To: T10 Technical Committee  
From: Rob Elliott, HP (elliott@hp.com)  
Date: 9 July 2006  
Subject: 06-281r2 SAS-2 Enable and disable zoning

### **Suggested changes to sas2r04a as modified by 06-279r1**

**Figure 5 — Physical presence detection extending a ZPSDS example**

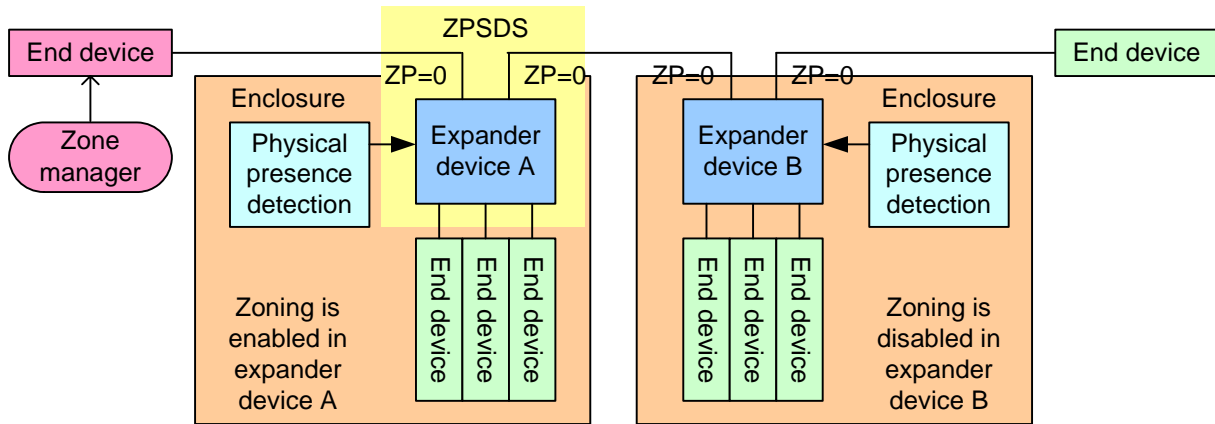
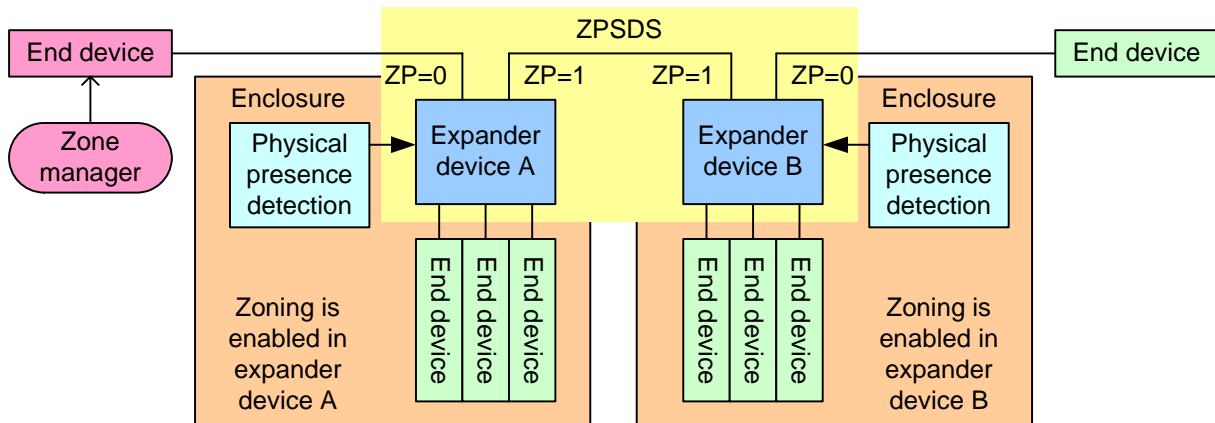
Figure 5 shows an example of two enclosures with physical presence detection where zoning is enabled in the expander device in the left enclosure, but is not enabled in the expander devices in the right enclosure. The zone manager is able to configure zoning in zoning expander device A because the zone group of its SMP initiator port has access to zone group 2. However, it is not able to enable or configure zoning in expander device B unless physical presence is asserted.

The ZPSDS is extended after the zone manager on the left:

- 1) configures zone phy information in each expander device, including setting the ZONE PARTICIPATING bit to one in each expander phy that is going to be inside the ZPSDS; and
- 2) sends a CONFIGURE ZONING request with the ZONING ENABLED bit set to one to expander device B while physical presence is asserted.

**Figure 6 — Physical presence detection overtaking a ZPSDS example**

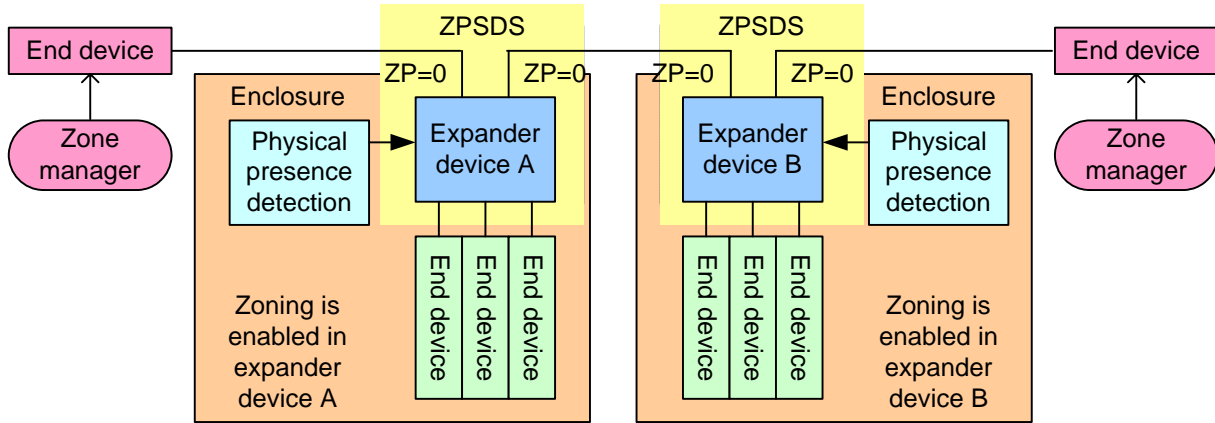
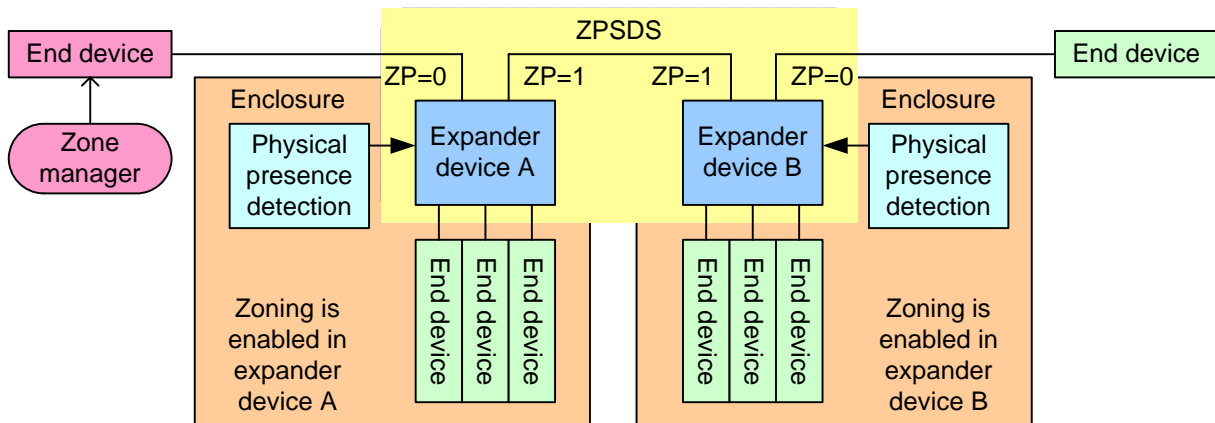
Figure 6 shows an example of two enclosures with physical presence detection where zoning is enabled in both the expander devices. The zone manager is able to configure zoning in zoning expander device A.

[because the zone group of its SMP initiator port has access to zone group 2. However, it is not able to configure zoning in expander device B unless physical presence is asserted.](#)

The ZPSDS is extended after the zone manager on the left:

- 1) sends a CONFIGURE ZONING request with the ZONING ENABLED bit set to zero to expander device B while physical presence is asserted;
- 2) configures zone phy information in each expander device, including setting the ZONE PARTICIPATING bit to one in each expander phy that is going to be inside the ZPSDS; and
- 3) sends a CONFIGURE ZONING request with the ZONING ENABLED bit set to one to expander device B while physical presence is asserted
